10.5. Draft amendment to NSDCP 2013: North Sydney CBD – Commercial tower setbacks and separation

AUTHOR: Wendy Lam, Strategic Planner - Urban Design

To seek Council's endorsement to amendments to the North Sydney Development Control Plan 2013, relating to built form guidelines for commercial towers as they apply to the North Sydney CBD, following public exhibition.

Figure 3: 65 Berry Street with 6m above podium setback to western boundary

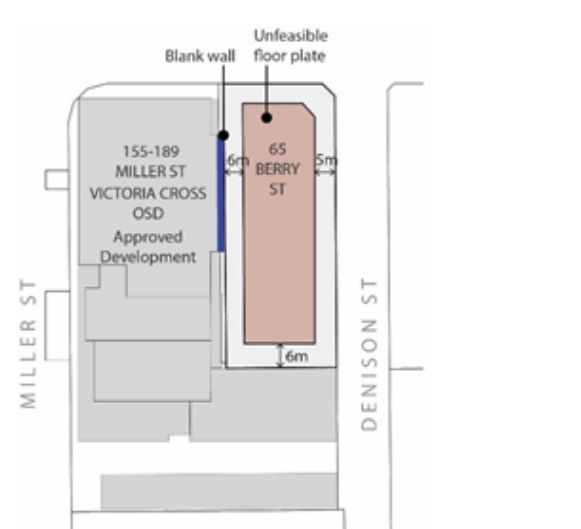
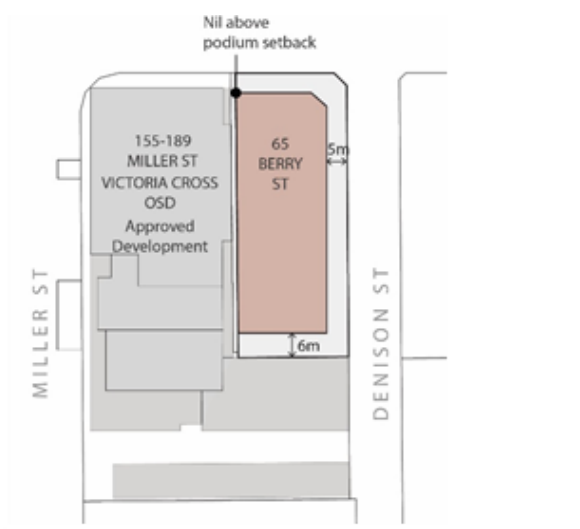
- 65 Berry Street (Figure 3 and 3A)
- 90 Arthur Street (Figure 4, 4A and 4B)
- 122 Arthur Street (Figure 5, 5A and 5B)
- 80 Mount Street (Figure 6 and 6A)
- 20 Berry Street (Figure 7 and 7A)
- 1 Wheeler Lane (Figure 8 and 8A)

It is recommended to include the western boundary of 65 Berry Street; southern boundary of 90 Arthur Street; southern boundary of 122 Arthur Street; eastern boundary of 84 Mount Street; northern boundary of 20 Berry Street; and southern boundary of 1 Wheeler Lane in Provision 24, Part C, Section 2.1. 3 to allow a nil above podium setback.

Figure 3A: 65 Berry Street with nil above podium setback to western boundary

Figure 9: Elizabeth Plaza and Hill Street urban blocks and proposed above podium setbacks

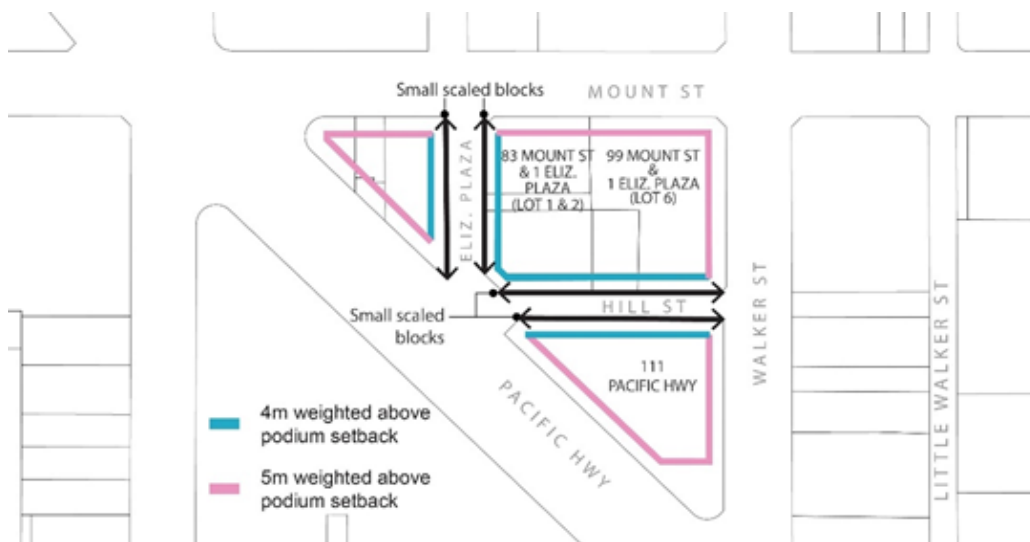
The Elizabeth Plaza and Hill Street laneways run alongside smaller scaled blocks formed by only up to 3 lot parcels. The length of these laneways is also significantly shorter in comparison to others in the CBD. (Figure 9)

To reflect the proportion of the urban block and scale of the laneways, it is recommended to reduce the weighted above podium setbacks from 5m to 4m for the eastern boundary of 2 Elizabeth Plaza; western boundaries of 83 Mount Street and 1 Elizabeth Plaza (Lots 2 & 4); northern boundary of 111 Pacific Highway; and southern boundaries of 1 Elizabeth Plaza (Lots 4 & 6) and 99 Mount Street (Figure C-2.3, Part C, Section 2.1.3).

Figure 10: East-west section through 132 Arthur Street with nil ground level setback

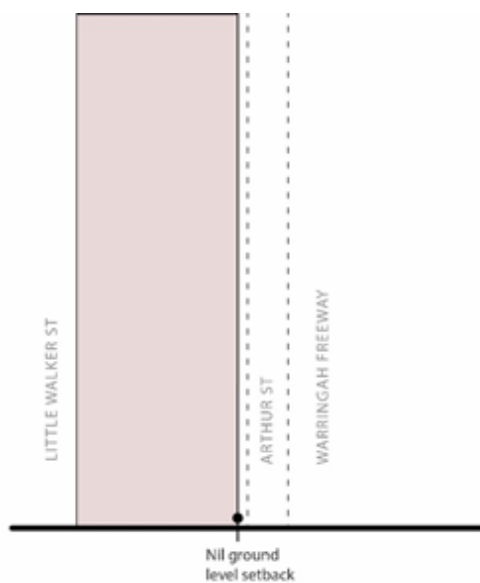
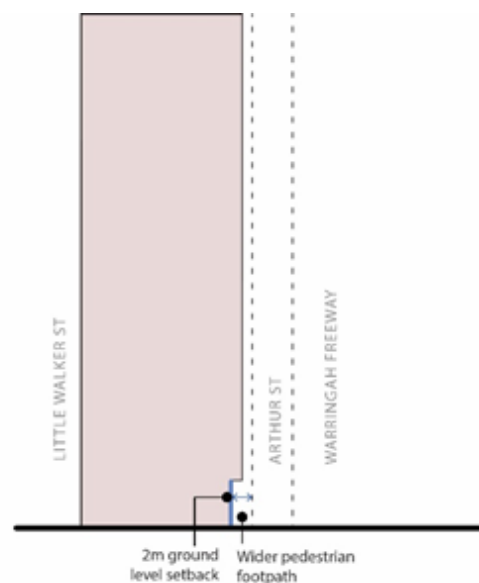
Currently, Arthur Street presents a nil ground level and above-podium setback along its entire street frontage that is bound by a busy road. This has created a hostile streetscape that is poorly activated due to its compromised pedestrian amenity. (Figure 10)

Incorporating a 2m ground level setback to the buildings along Arthur Street will craft a more pedestrian friendly street, providing a protected footpath that is wider and further set back from Warringah Freeway. (Figure 10A)

Figure 10A: East-west section through 132 Arthur Street with 2m ground level setback
